Well information: **30-045-05424 CENTRAL BISTI UNIT #069**

Plug and Abandonment Procedure Post Fishing
for
DJR Operating, LLC
Central Bisti Unit 69
API # 30-045-05424
NW/NE, Unit B, Sec. 16, T25N, R12W
San Juan County, NM

BLM FLUID MINERALS Geologic Report

CONDITIONS OF APPROVAL

Proposed P&A Wellbore Diagram

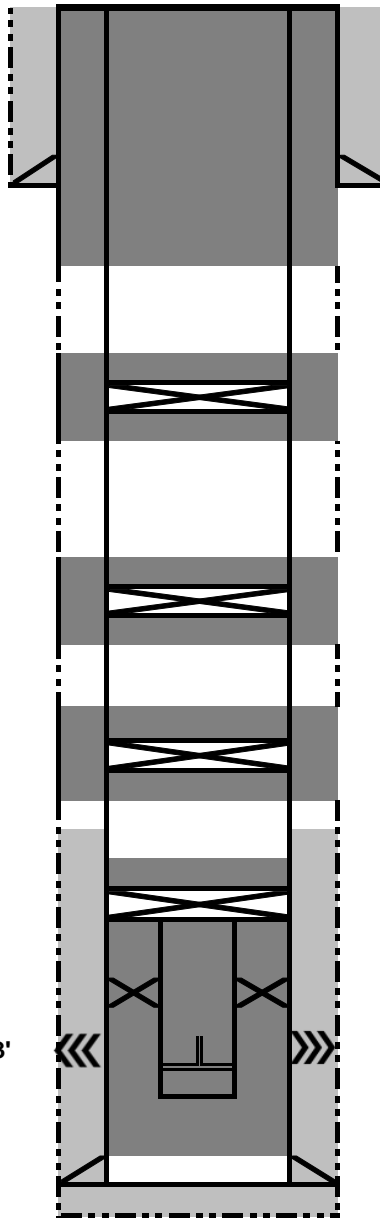
- Add a plug 1510'-1410'. OCD Chacra pick @ 1460'..

- Please ensure that the tops of the Pictured Cliffs, and Fruitland formations, as well as the entire Ojo Alamo aquifer, identified in this report, are isolated by proper placement of cement plugs. This will protect the freshwater sands in this well bore.

- Please note that the BLM geologist's pick for the Cliff House formation varies from the operator's pick.

1. Plugging operations authorized are subject to the attached "General Requirements for Permanent Abandonment of Wells on Federal and Indian Lease"
2. Farmington Office is to be notified at least 24 hours before the plugging operations commence (505) 564-7750
3. BLM Geologist picks top of Cliffhouse at 2190' MD. Extend plug 4 or add a plug to cover 2140 – 2240 MD.
